REMARKS

DRAWING ISSUES

FIGURE 1

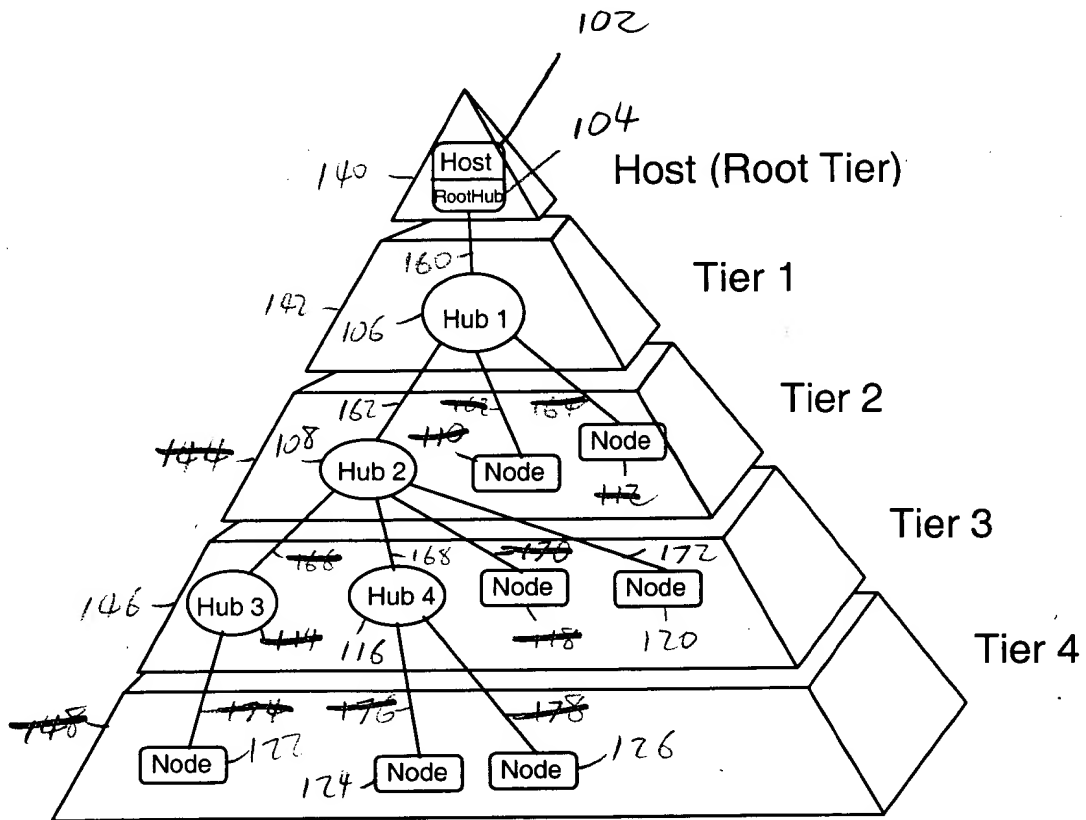
In the Office Action at paragraph 4, certain reference numbers in Figures 1, 2, 5, 6, and 7 were objected to as not referenced in the written specification. Applicant has crossed out the cited reference numbers in red ink on the enclosed copies of Figures 1, 5, 6, and 7 as a proposed drawing change. A citation to reference number 210 of Figure 2 has been added to the paragraph beginning at page 5, line 22 and extending to page 6, line 6. Additionally, reference number 642 has been removed from Figure 6.

NODE Y 710 740
 NODE Z
 FIGURE 8

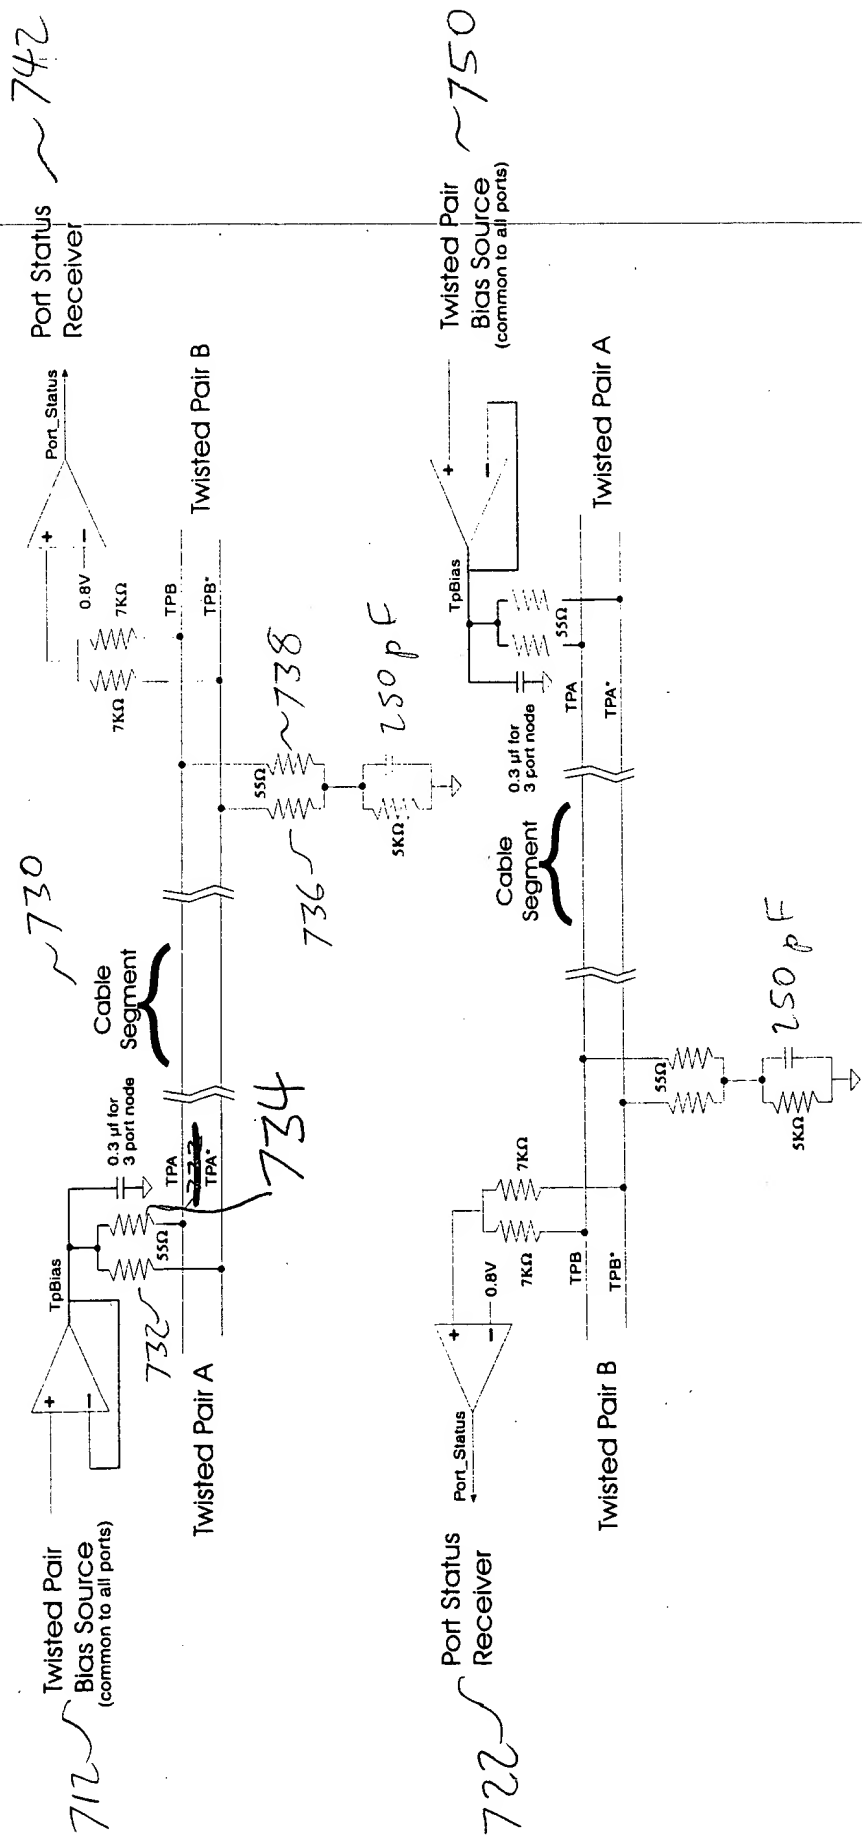
In the Office Action at Paragraph 5, Figure 8 was objected to as having two uses of reference number 732. In the attached revision of Figure 8 in red ink, applicant has corrected the reference to the pull-up resistor connected to TPA* to now read 734. Additionally, applicant has revised the paragraph beginning at page 16, line 5 and extending to page 16, line 17 to now recite "pull-up resistors 732, 734".

Referring now to Figure 8, a schematic diagram of an IEEE 1394 bus pull-up resistor bias source is shown. Node Z 740 may detect the physical attachment of node Y 710 due to a voltage bias provided by twisted pair bias source 712. Twisted pair bias source 712 includes a pair of pull-up resistors 732, 734 [742], which supply a biasing voltage TpBias to a twisted pair within cable segment 730 when node Z 740 is

attached to node Y 710 with cable segment 730. Biasing voltage TpBias is split by the action of the pull-up resistors 732, 734, and the pull-down resistors 736, 738, which are connected at one end to AC ground within node Z 740. Port status receiver 742 may note the presence of this split biasing voltage on the twisted pair wires, and indicate this presence to other circuits within node Z 740 as an indication of the physical attachment of node Y 710.
